Old type Nordhydraulic RS210 spool sensor can no longer be supplied.

New type Nordhydraulic RS210 which can replace the old type

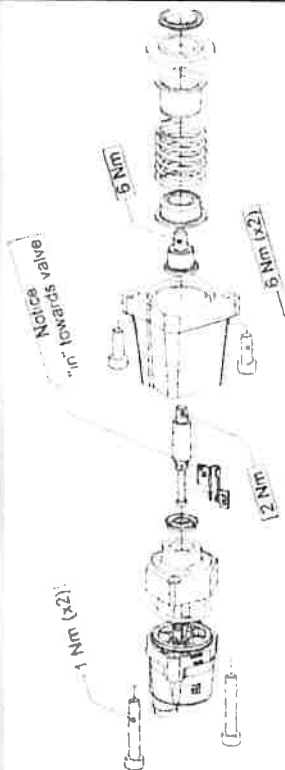
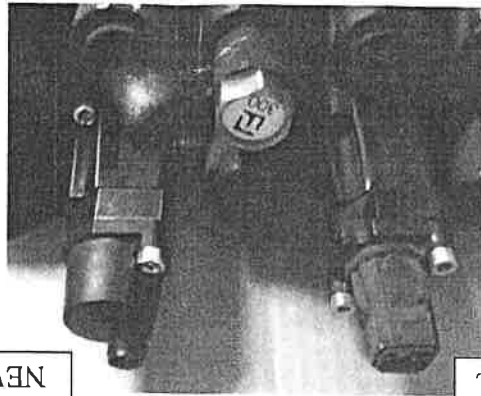
New spool sensor Part no. 69530
New cable Part no. 28117

Old cable, wire no.	New cable, Wire color	Connection
1	Blue	-
2	Brown	+
3	Black	Signal
4	White	Signal
